November 16, 2021

RE: Submission of 2021 Geotechnical Inspection Report No. 2 (September 2021)

The second geotechnical inspection for 2021 was conducted by Laszlo Bodi, M.Sc., P.Eng., Principal Civil/Geotechnical Engineer with Wood Environment and Infrastructure Solutions. The focus of the inspection was on the Water Licence related infrastructure located at the Mary River Mine Site and Milne Port, as well as select water crossings along the Milne Inlet Tote Road. The second geotechnical inspection for 2021 was conducted between September 14 and 17, 2021.

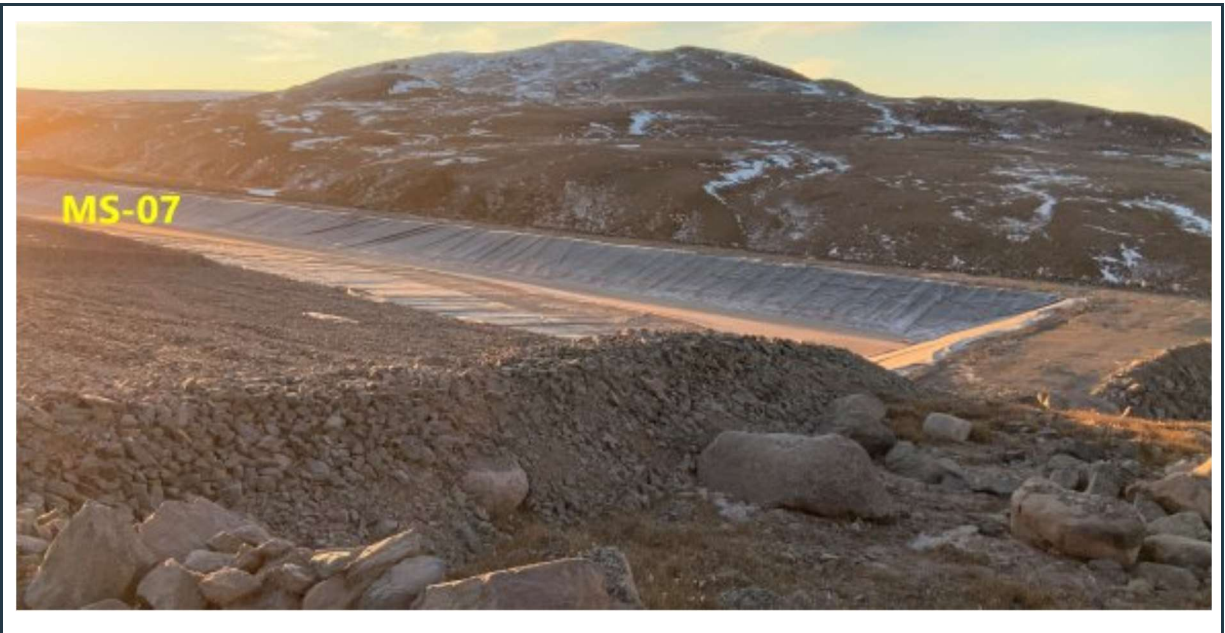
The temporary containment sump that was excavated to contain seepage water for diversion back to the settling pond could endanger the stability of the existing berm, and therefore must be backfilled with native soil prior to freshet.

Figure 22: Seepage water within the relatively permeable, cobbly overburden adjacent to the area of the crusher pad and MS-06 pond. It appears to be surface water, percolating down into the ground and flowing from higher elevations within the valley adjacent to the crusher pad. The excavated hole (temporary sump) at the toe of the MS-06 berm must be filled (yellow circle).

Baffinland Action: Baffinland will backfill the containment sump to maintain the structural integrity of the pond berm (Completion prior to Freshet 2022).

Figure 29: View of the snow stockpile adjacent to the “fuel bladder” cell. The melting snow has flooded the adjacent road next to the berm during the summer. It is recommended to excavate perimeter drainage ditches around the stockpile and prevent flooding of the road and berm.

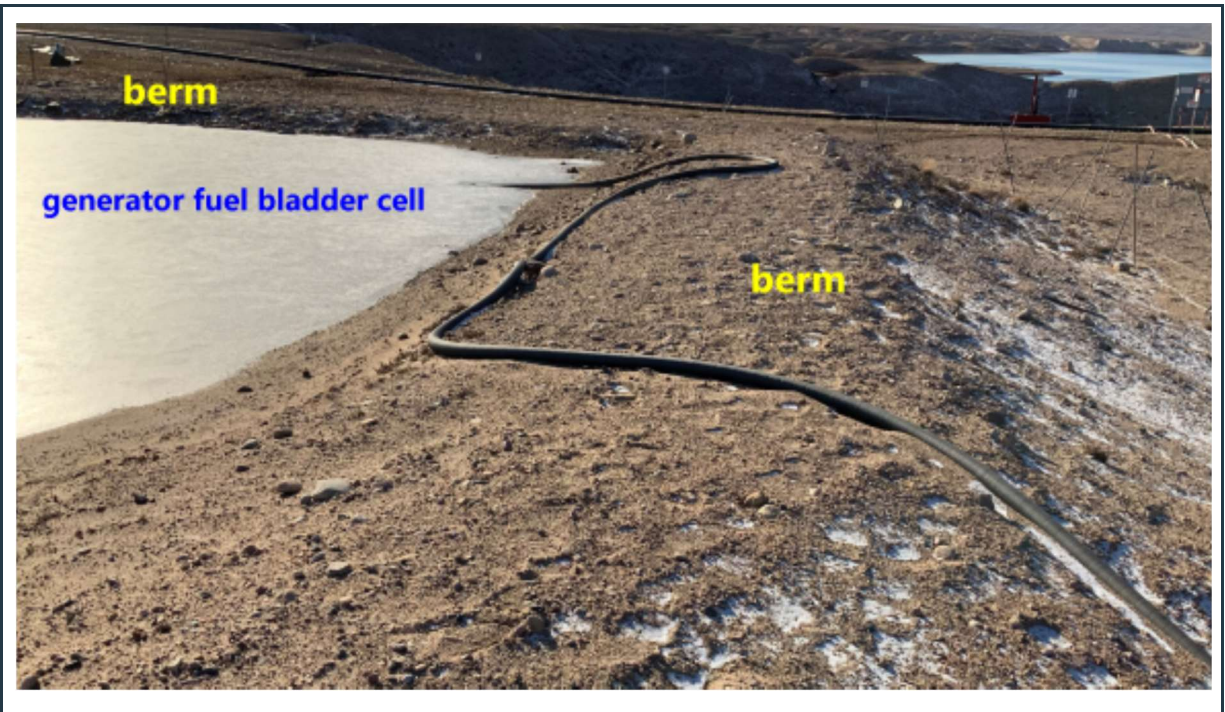
As previously recommended in the June 2021 report, to prevent further deterioration of the pond's berm, the drainage of melting snow in the area must be rectified permanently. The surface water should be redirected away from the berms by excavating properly designed and constructed drainage ditches in the area, preferably around the adjacent snow stockpile.

Baffinland Action: Drainage ditches will be constructed in the area to prevent further deterioration of the pond's berm (Completion prior to Freshet 2022).

Figure 35: Rock fill riprap slope protection at the water discharge area. Note that some of the rock fill had “moved” to the toe of the slope. It is recommended to place new rock fill in the area marked with the yellow circle.

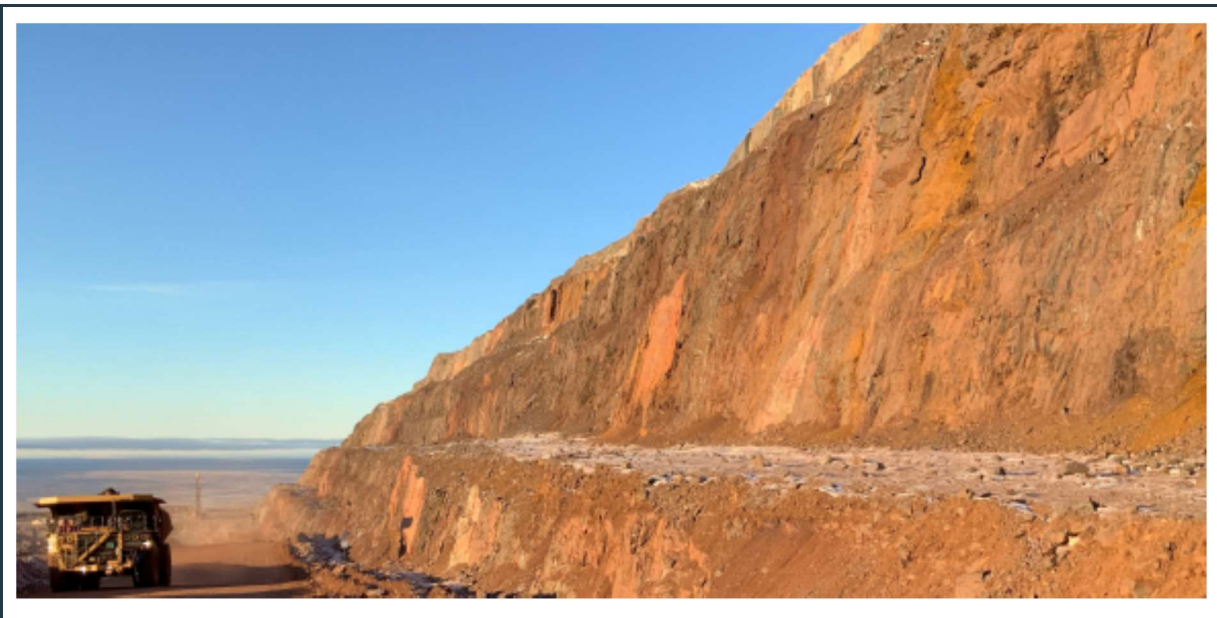
Some of the rock fill has been "washed down" from the crest to the toe of the slope in a small area. It is recommended that area be filled with additional rock fill to prevent the erosion of the underlying finer material down the slope.

Figure 46: Stable berms and intact liner in the MP-01A pond. The waste (soil and wood), shown in part of the pond, should be removed without damaging the liner.

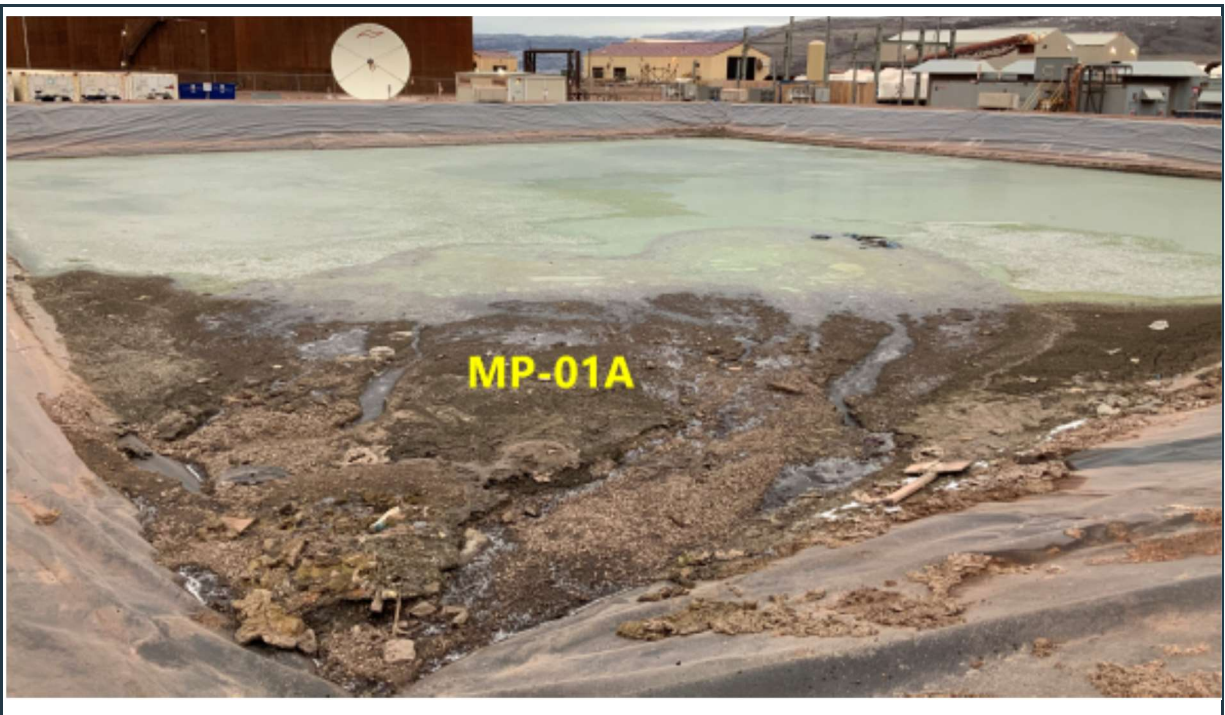
The MP-01A polishing pond is located immediately south of the MP-03 fuel tank site. As shown in Figure 46, the berms around the well-maintained pond are in excellent condition and the liner within the cell appears to be intact. No sign of slope instability, settlement or seepage from the pond was noted during the field inspection. As shown in Figure 46; however, some sewage sludge accumulation was visible in one (1) corner of the pond, which should be removed from the cell. This should be removed carefully, so as not to damage the HDPE liner on the berm.

Baffinland Action: Baffinland will assess the solids build up within PWSP MP-01A and if necessary will develop an implementation plan to remove the solids from the corner of the pond using a method that does not damage the liner (Completion Q3 2022).

Figure 88: View of the inlet of culvert BG-03A.

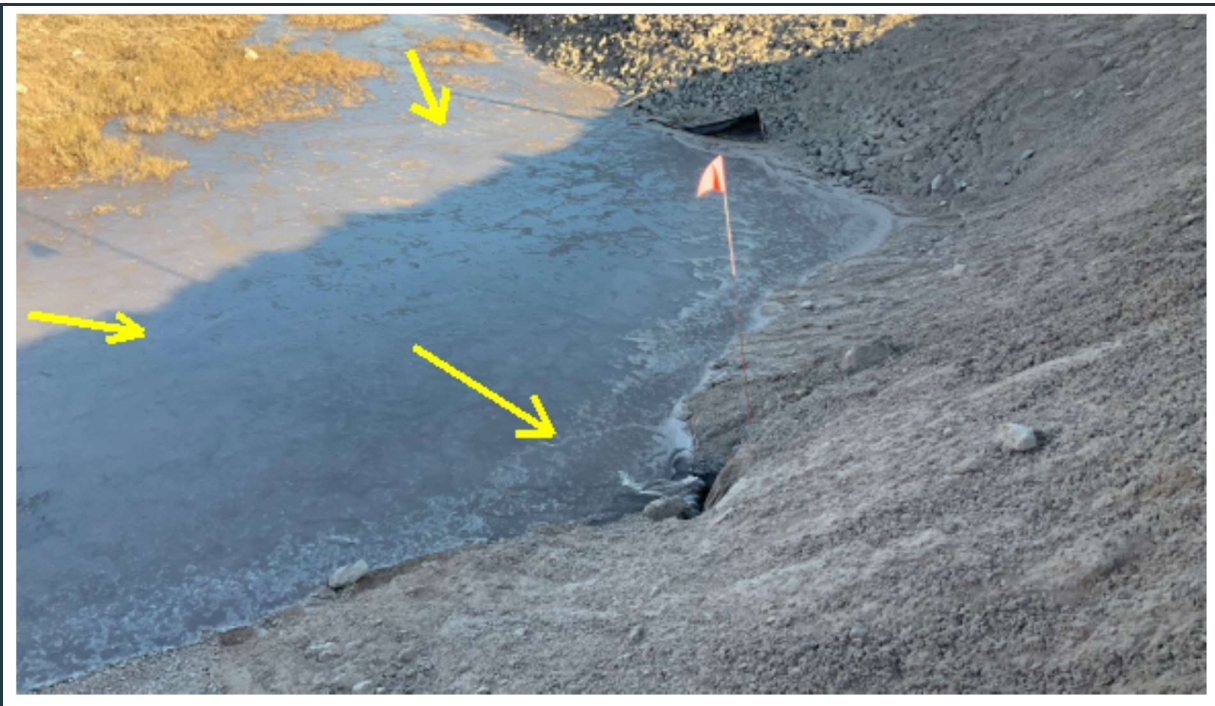
Culvert BG-03A (KM 95+500) - (Figure 88 and Figure 89): The BG-03A culvert pipe was replaced in 2020 as per the approved Hatch Tote Road Plan. The inlet-end of this culvert appears to be short, and no rock fill riprap is protecting the vicinity of the inlet from erosion/siltation. Furthermore, the diameter of the culvert may potentially be too small for this location, which could result in flooding of the area upstream of the inlet during spring freshet. It is suggested that the efficiency of the culvert be monitored in the spring/early summer of 2022.
